UNITED STATES  
DEPARTMENT OF THE INTERIOR  
BUREAU OF LAND MANAGEMENT

**SUNDRY NOTICES AND REPORTS ON WELLS**  
**Do not use this form for proposals to drill or to re-enter an**  
**abandoned well. Use Form 3160-3 (APD) for such proposals.**

1. Type of Well <input checked="" type="checkbox"/> Oil Well <input type="checkbox"/> Gas Well <input type="checkbox"/> Other		5. Lease Serial No. NMLC-061863-A
2. Name of Operator DEVON ENERGY PRODUCTION CO LP		6. If Indian, Allottee or Tribe Name
3a. Address PO BOX 250, ARTESIA, NM 88211	3b. Phone No. (include area code) 575-748-3371	7. If Unit of CA/Agreement, Name and/or No.
4. Location of Well (Footage, Sec., T., R., M., or Survey Description) SL: 200' FSL & 2310' FEL, UNIT O, SEC 6, T25S, R32E		8. Well Name and No. TRIONYX 6 FEDERAL #5H
		9. API Well No. 30-025-40045
		10. Field and Pool or Exploratory Area WILDCAT, BONE SPRING
		11. Country or Parish, State LEA COUNTY, NM

DEVON ENERGY PRODUCTION CO. LP respectfully requests to revise the interim reclamation diagram (please see attached) for the Trionyx 6 Federal #5H.

Figure 1 – Cross Sections and Plans For Typical Road Sections

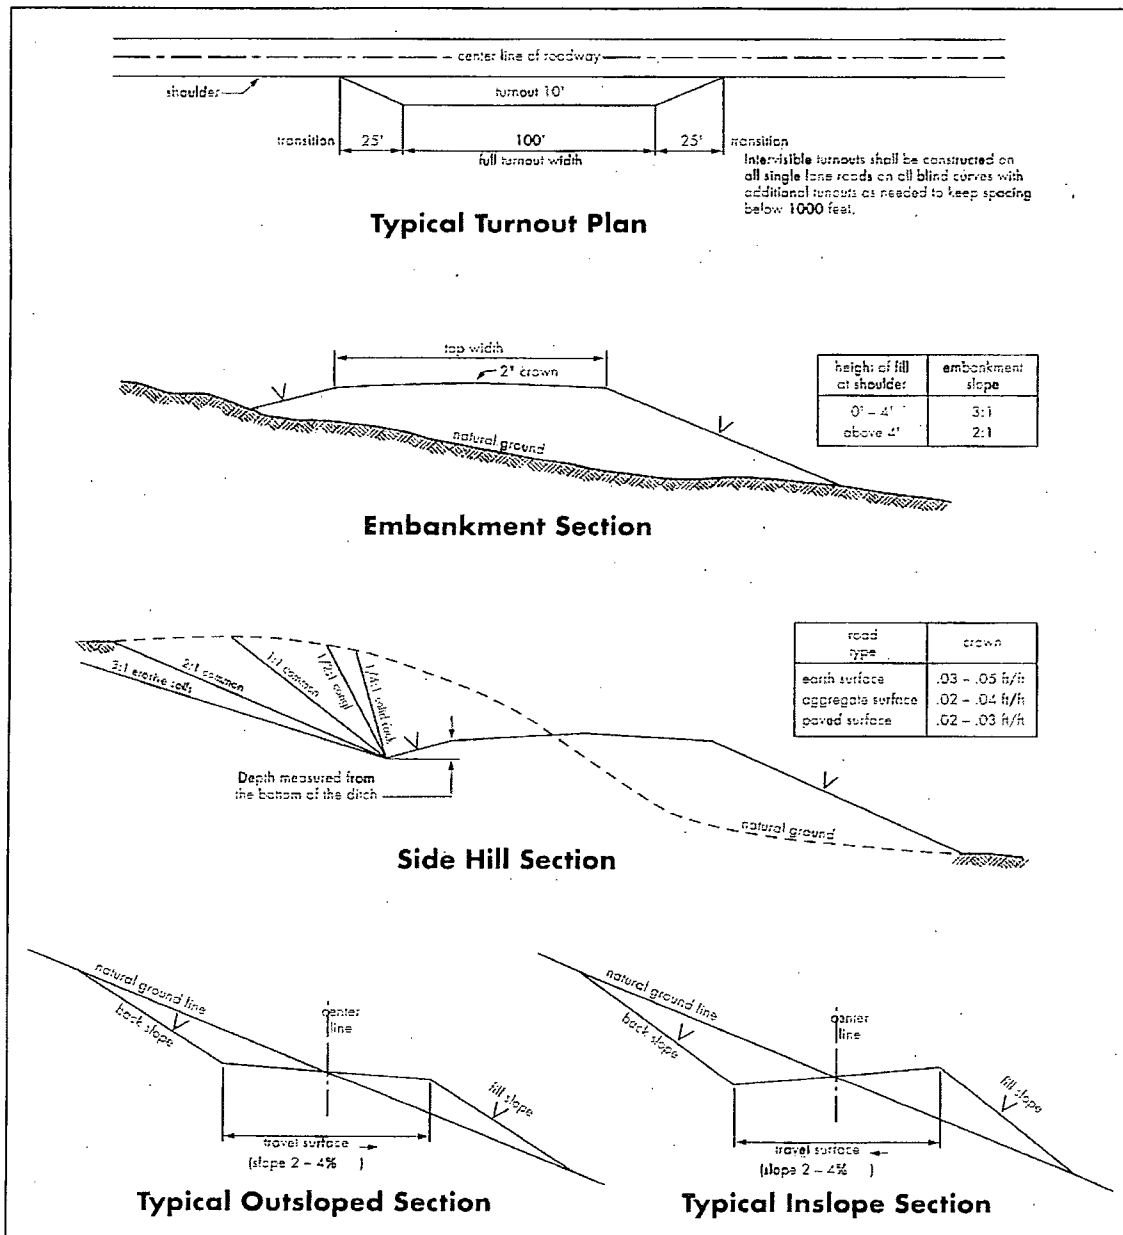
Crowning shall be done on the access road driving surface. The road crown shall have a grade of approximately 2% (i.e., a 1" crown on a 14' wide road). The road shall conform to Figure 1; cross section and plans for typical road construction.
